**HISTORIC LANDMARK COMMISSION  
STAFF REPORT**

**Park Strip Raised Garden Beds**  
PLNHLC2014-00334  
584 E 3<sup>rd</sup> Avenue  
Meeting Date: August 7, 2014

This is a request by Heidi Keilbaugh, the property owner, to allow seven (7) existing raised planter beds in the park strip, and construct four (4) additional raised planter beds in the park strip, at approximately 584 E 3<sup>rd</sup> Avenue.

**ATTACHMENT A**  
Site Plan

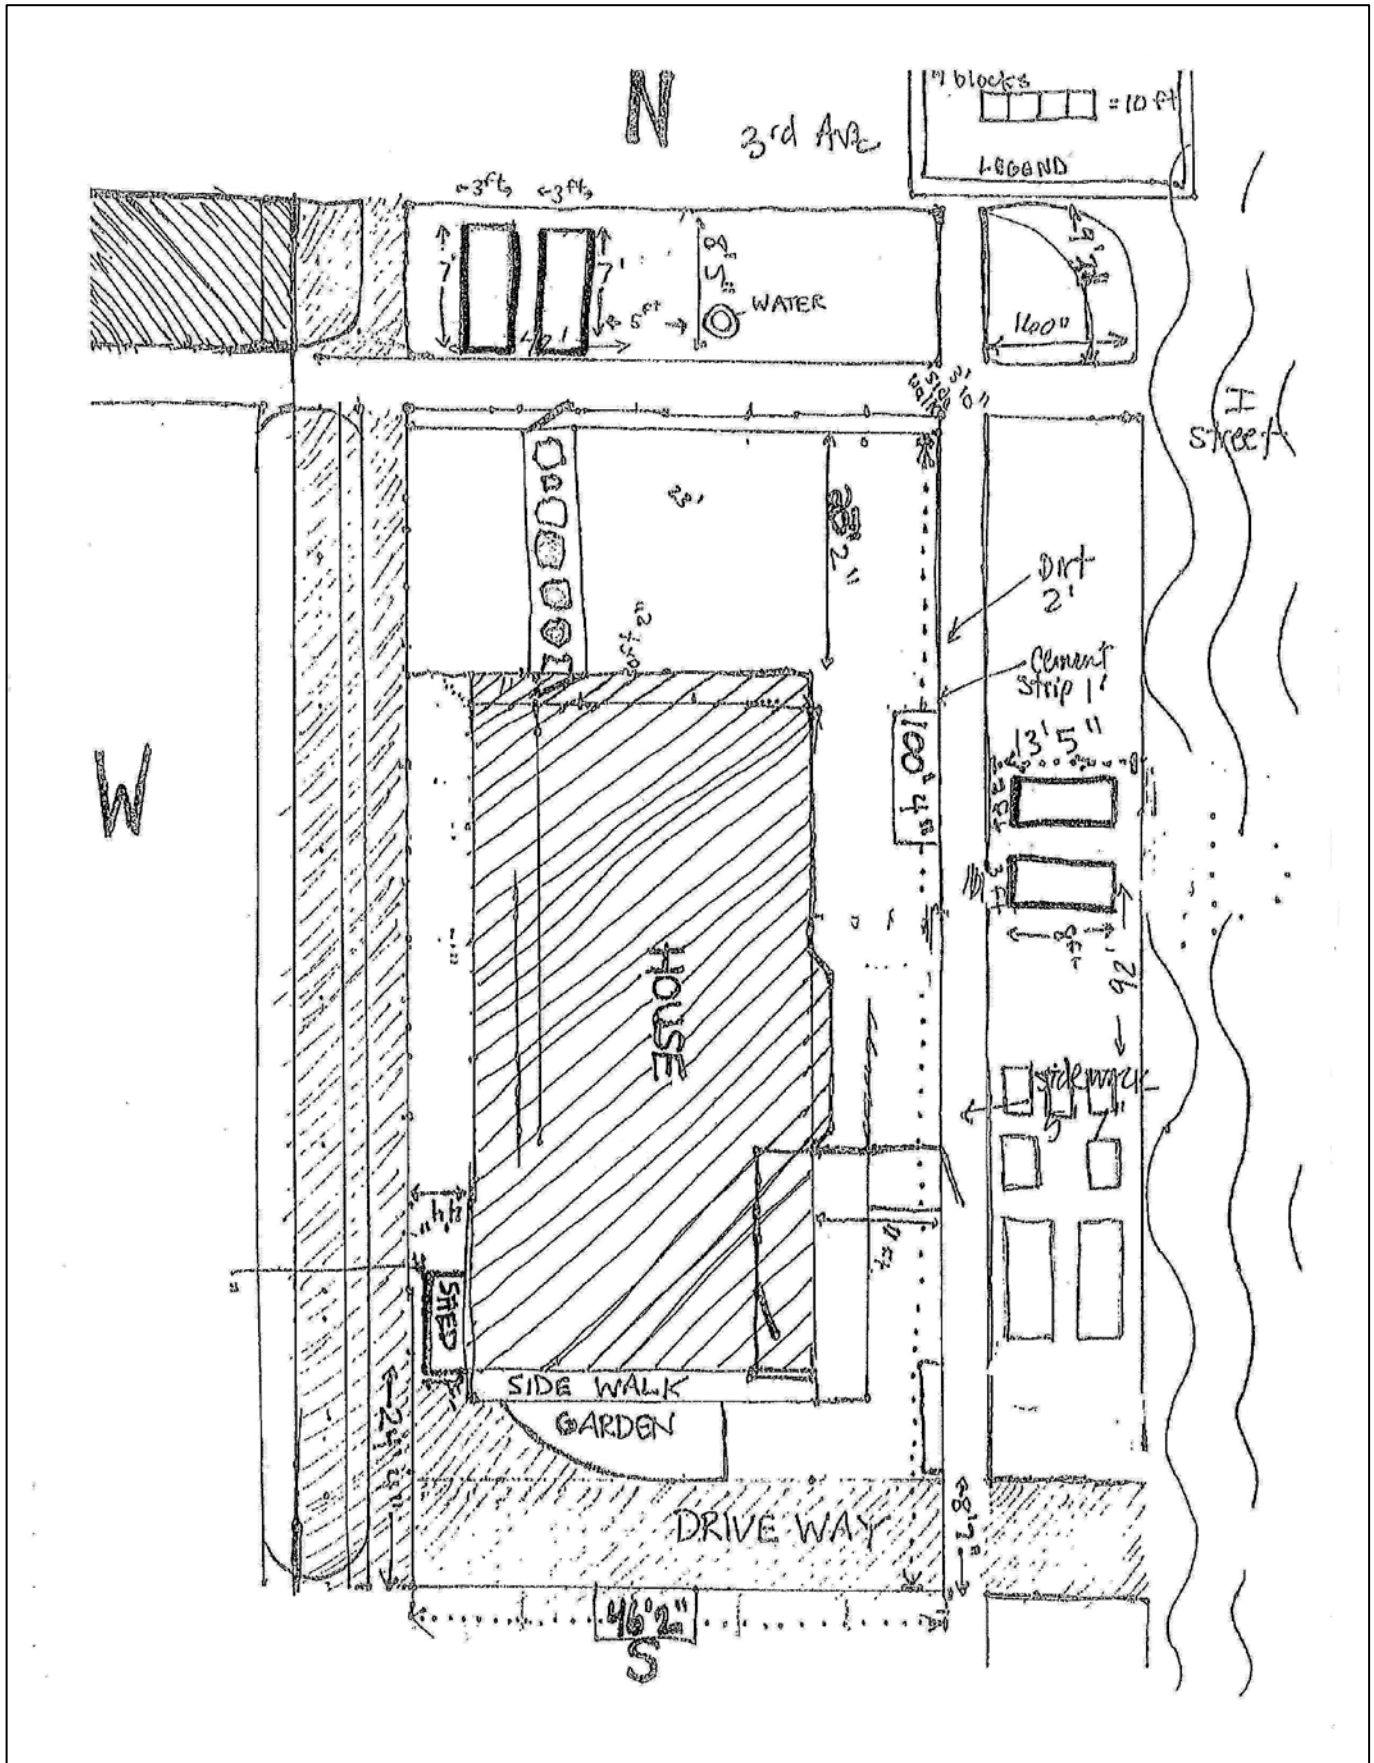
The Fire Department Fire is requiring a three foot clearance around the fire hydrant, as well as nothing blocking the outlet ports of the fire hydrant. A reprint of the sections from the International Fire Code (IFC) are provided below:

The proposed planters are located such that they do not pose a barrier between the roadside parking and the public sidewalk, and maintain the required 2 foot set-back from the curb. The planters and vegetation need to comply with the required 10'x10' clear sight zone height restriction of 30 inches maximum height in order to provide a safe visible zone on each side of all driveways crossing the public sidewalk (See Diagram in Attachment C).

**Analysis:** Staff has reviewed the zoning requirements for park strip landscaping as they relate to this application. The raised garden beds introduce a new structural encroachment into the park strip which is prohibited without a revocable permit. The revocable permit is pending historic approval of the application. Annual and perennial plants are permitted not to exceed eighteen inches (18”) in height at maturity when located within sight distance areas at street intersections, alleys, or driveways (see diagram in attachment 3). Once planted with vegetation up to twenty four inches (24”) in height, the proposed twelve inch (12”) raised garden beds located in the park strip adjacent to 3<sup>rd</sup> Avenue, will have combined heights greater than eighteen inches (18”). As proposed, the raised garden beds adjacent to 3<sup>rd</sup> Avenue do not meet sight distance triangle requirements.

**Finding:** For the reasons outlined in the analysis, the proposal does not meet the standards of the Park Strip Landscaping ordinance. The proposed raised garden beds adjacent to 3<sup>rd</sup> Avenue do not meet the sight distance triangle requirements. The raised garden beds are a structural encroachment that limits access and from the street to the sidewalk. Structural encroachments are prohibited unless they are approved through the city’s revocable permit and review process. Revocable permit approval for this project is pending the outcome of Certificate of Appropriateness approval of the raised garden beds.

Fire has one issue and that is we need three feet clearance around the fire hydrant, as well as nothing blocking the outlet ports of the fire hydrant. A reprint of the sections from the International Fire Code (IFC) are provided at the end of this email.

The proposed planters are located such that they do not pose a barrier between the roadside parking and the public sidewalk, and maintain the required 2 foot set-back from the curb. Please note on the drawing that the planters and vegetation needs to comply with the required 10'x10' clear sight zone height restriction of 30 inches maximum height in order to provide a safe visible zone on each side of all driveways crossing the public sidewalk. (Standard detail E2.c2.)
